# CHANGE TO THE PULLEYS OF A FEW TENSIONING ARMS FOR THE ACCESSORY UNIT DRIVE

TECHNICAL INFO NO. 1035

Image 1: Detailed view of pulley in its previous design (left) and new design (right)

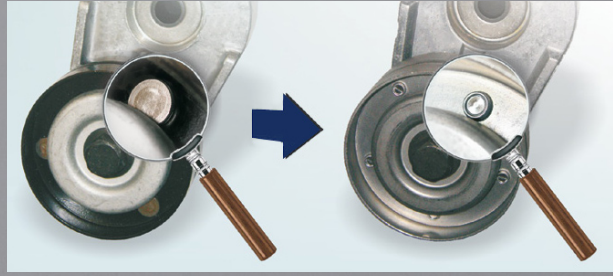
The differences are, as are shown in Image 1, the coating (previously black, now metal) and the connection between both race halves (previously riveted, now tox clinched).

During the transition period, we may have mixed stocks of both designs. Both versions meet the technical specifications and can be used without restrictions on the vehicles specified in the catalogue.
